**THE DETERMINATION OF MINIMUM FLOWS FOR SULPHUR
SPRINGS, TAMPA, FLORIDA**

SCIENTIFIC REVIEW PANEL

Scientific Review Panel Report

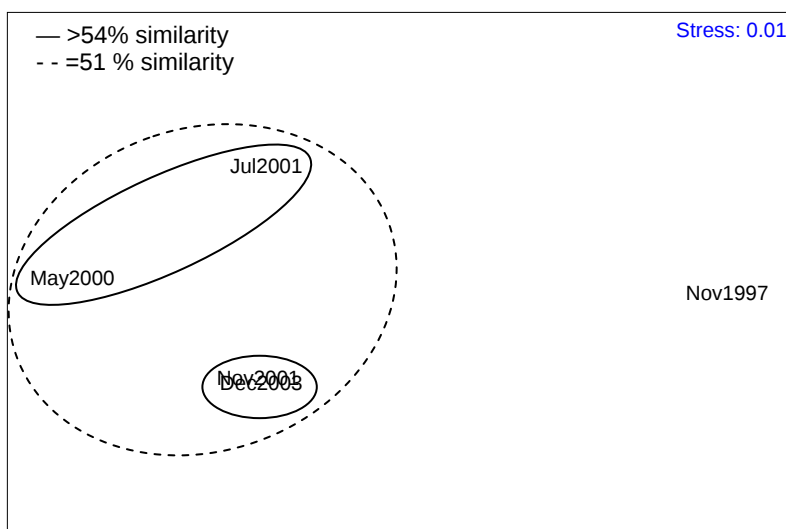
The discussion of macrofaunal changes in the text (Section 3.7.3) is based on simply comparing highlighted species. A statistical analysis is preferred, and the MDS approach provides a less subjective and more robust analysis. When this analysis is performed, the 1997 community structure (after a prolonged drought and period of withdrawal) was different from the other four sampling times, and shares only 38% similarity with samples collected after May 2000. However, November 2001 and December 2003 (occurring during high flow) are very similar (57%), and the May 2000 and the July 2001 samples (occurring during low flow) were also very similar (54%). All four of these sampling dates shared 51% of species in common. This discussion above is similar to that presented in the text (pages 3-21 through 3-22), but it adds some statistical certainty.
